### HISTON ROAD STAKEHOLDER WORKSHOP REPORT - (PART 1) THE GREATER CAMBRIDGE CITY DEAL

**Cambridgeshire County Council**

Project no: 70012012 Date: January 2017

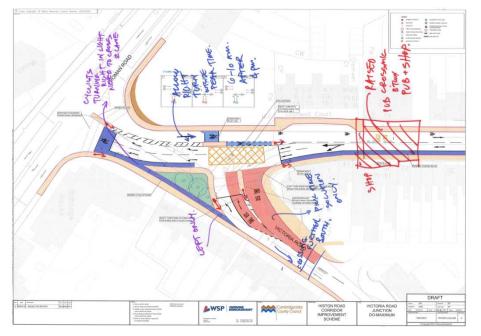
3.3.16 There is little to no consistency between the two proposed cross sections at Hazelwood Close. The only common ground is the allocation of space to green verges in excess of what is allocated in the "Do Maximum" design.

Figure 3-4: Table 2 Victoria Road Junction Design

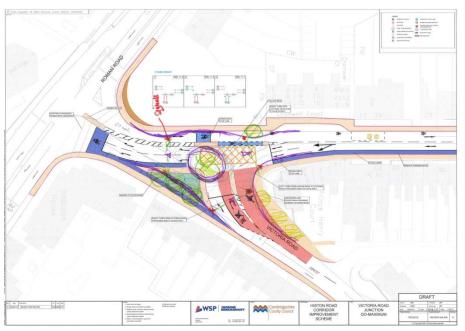
→ Replace the junction at the intersection of Histon Road and Victoria Road with a signalised roundabout where all left turning cycle movements have clear through movements.

#### Figure 3-5: Table 3 Victoria Road Junction Design

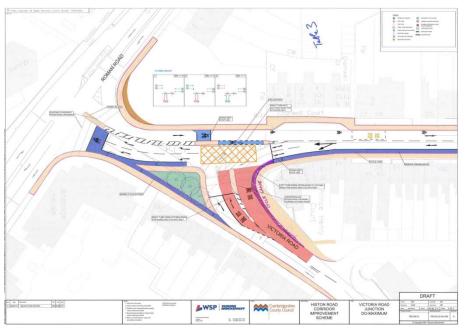
- Provide a left turn cycle lane from Histon Road north to Victoria Road which bypasses the signals.
- 3.4.5 In addition to the concepts produced at the workshops, the following design was submitted by Histon Road Area Residents Association with assistance from a representative of the Cambridge Cycling Campaign, for the Victoria Road junction.

Figure 3-8: Table 2 (1A) Gilbert Road Junction Design

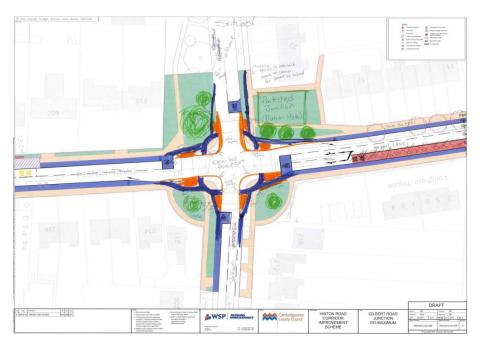
- → This table proposed a "Protected Junction (Dutch-style)" which incorporates segregated pedestrian and cycle movements in all directions; and
- $\rightarrow$  A parallel crossing is present at each arm.

#### Figure 3-14: Table 3 Kings Hedges Junction Design

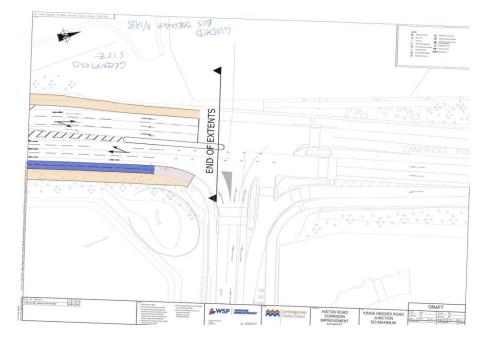
#### 3.4.14 Table 3 Junction Feedback
